THE PE STAMP IN THIS PLAN SET COVERS ONLY THE MODIFICATIONS SHOWN CLOUDED IN RED AND SIGNIFIED BY △. WHICH MODIFY THE ORIGINAL BRIDGE PLANS TO UTILIZE A TRADITIONAL FULL-DEPTH, CAST IN PLACE CONCRETE DECK. THE DECK REINFORCEMENT IS DESIGNED PER THE CURRENT WISCONSIN DOT BRIDGE MANUAL.

NO.	DATE	REVISION	BY
△	8/09/18	REMOVE PRECAST DECK PANELS	AYRES
△	7/10/18	MISC REVISION	JRM

STRUCTURE B-51-126

IH 94 NB AND RAMP OVER STH 11 AND CPRR

DECK HAUNCH DETAIL

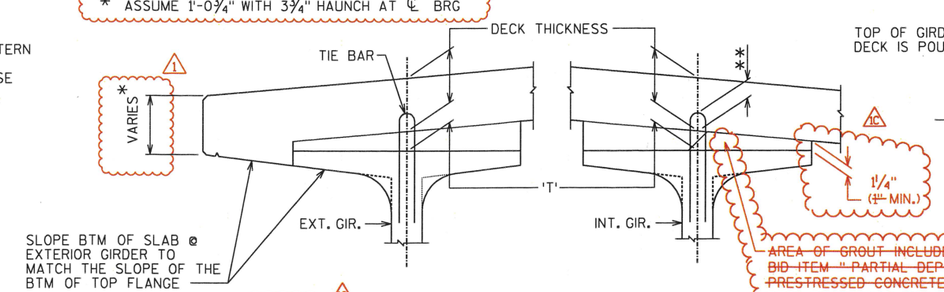
1C 1 1/4" IF ~~1"~~ MINIMUM HAUNCH HEIGHT AT EDGE OF GIRDER CANNOT BE MAINTAINED, THE ~~GRADE~~ LINE MAY BE REVISED BY THE ENGINEER AT THE OPTION OF THE CONTRACTOR, THE PLAN DECK THICKNESS SHALL BE HELD. NOTIFY THE STRUCTURES SECTION IF THE GRADE LINE IS RAISED FROM THE PLAN PROFILE BY MORE THAN 1/2" OR,

1C NOTE: THE AVERAGE HAUNCH ('T') WAS CALCULATED AS 3 1/4" ~~3". GROUT IN HAUNCH AREAS INCLUDED IN THE BID ITEM "PARTIAL DEPTH PRECAST PRESTRESSED CONCRETE DECK PANEL B-51-126".~~

PLAN

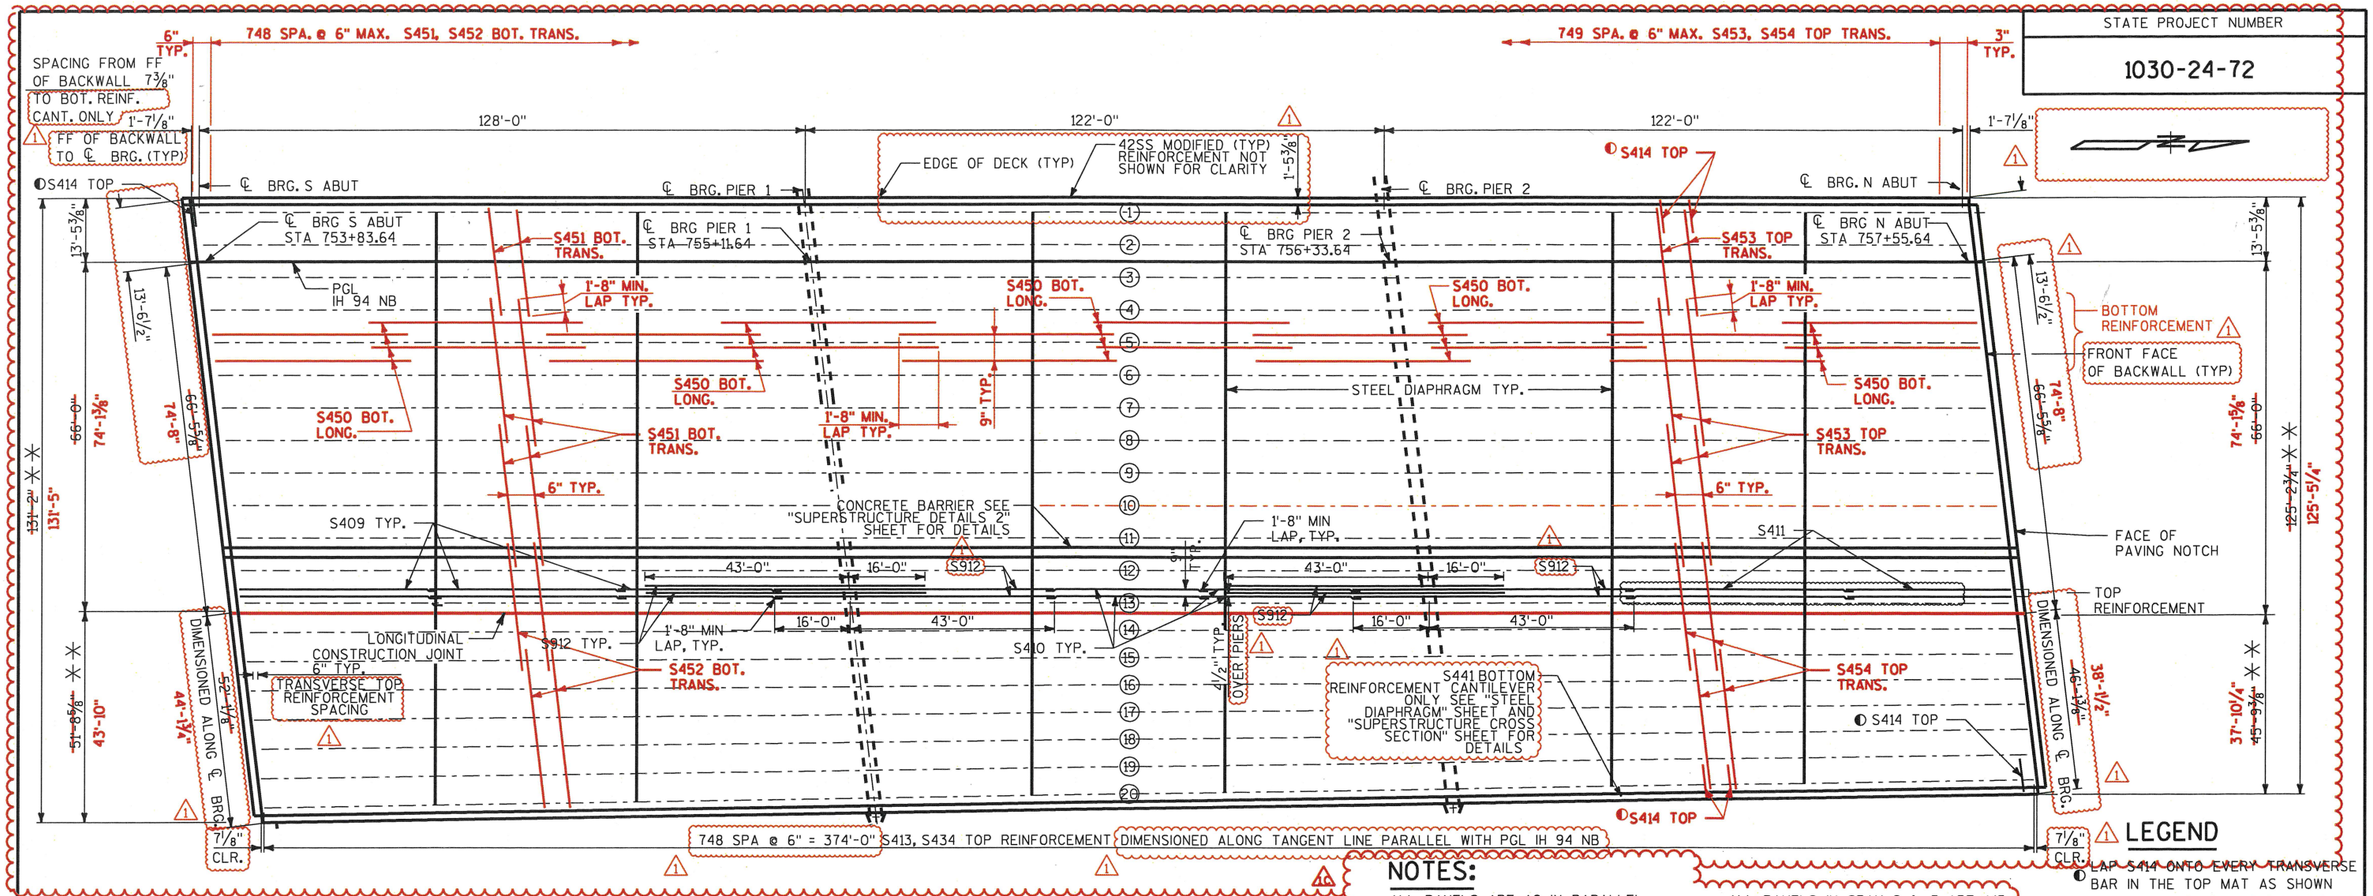
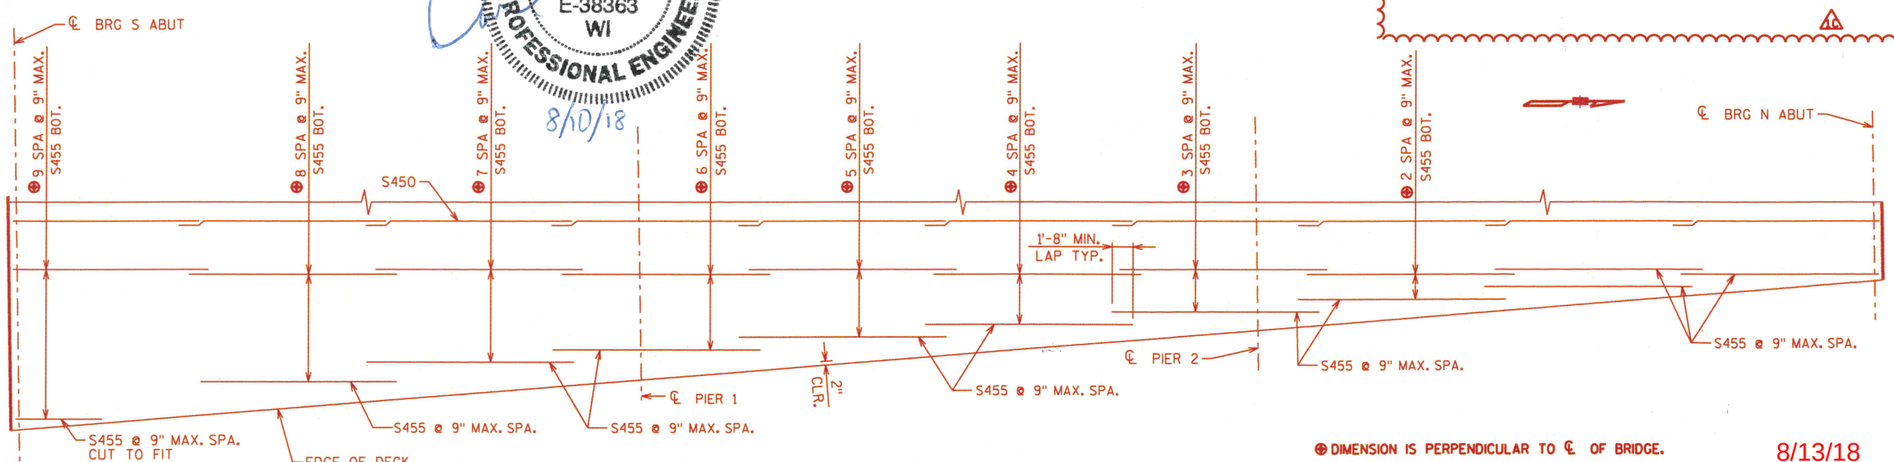
~~ALL PANELS ARE A2 IN PARALLEL GIRDER AREAS UNLESS NOTED OTHERWISE.~~ PARALLEL GIRDER AREAS ARE BETWEEN GIRDERS G1 & G13.

~~ALL PANELS IN SPAN 1 ARE A8 IN FLARED GIRDER AREAS UNLESS NOTED OTHERWISE.~~ FLARED GIRDER AREAS ARE BETWEEN G13 & G20.

~~ALL PANELS IN SPAN 2 & 3 ARE A15 IN FLARED GIRDER AREAS UNLESS NOTED OTHERWISE.~~ FLARED GIRDER AREAS ARE BETWEEN G13 & G20.

~~✳ DIMENSIONS TO PANEL EDGE VARIES BETWEEN GIRDERS G13 G20. DIMENSION GIVEN IS A MINIMUM. PANELS SHOULD EXTEND INTO PIER & ABUTMENT DIAPHRAGMS 1 1/2" MIN. "SEE SUPERSTRUCTURE DETAILS 1" FOR SECTION~~

END SKEW DECK PANEL

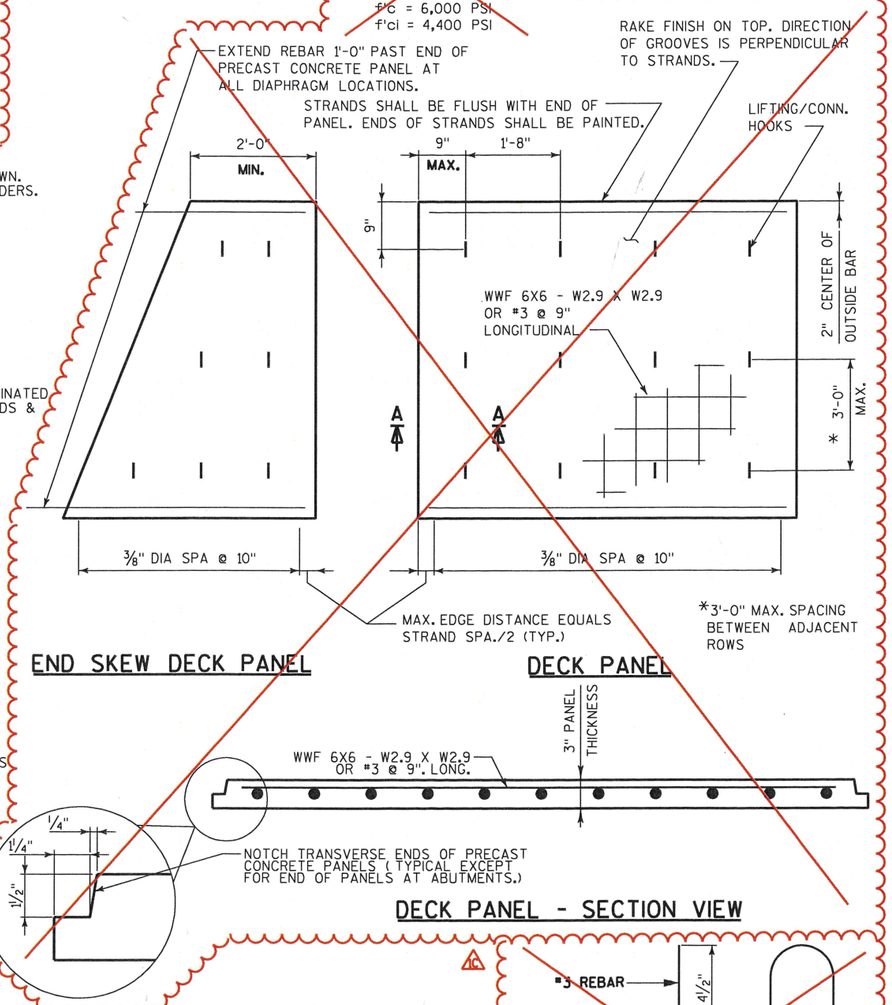
THE PE STAMP IN THIS PLAN SET COVERS ONLY THE MODIFICATIONS SHOWN CLOUDED IN RED AND SIGNIFIED BY 1. WHICH MODIFY THE ORIGINAL BRIDGE PLANS TO UTILIZE A TRADITIONAL FULL-DEPTH, CAST IN PLACE CONCRETE DECK. THE DECK REINFORCEMENT IS DESIGNED PER THE CURRENT WISCONSIN DOT BRIDGE MANUAL.
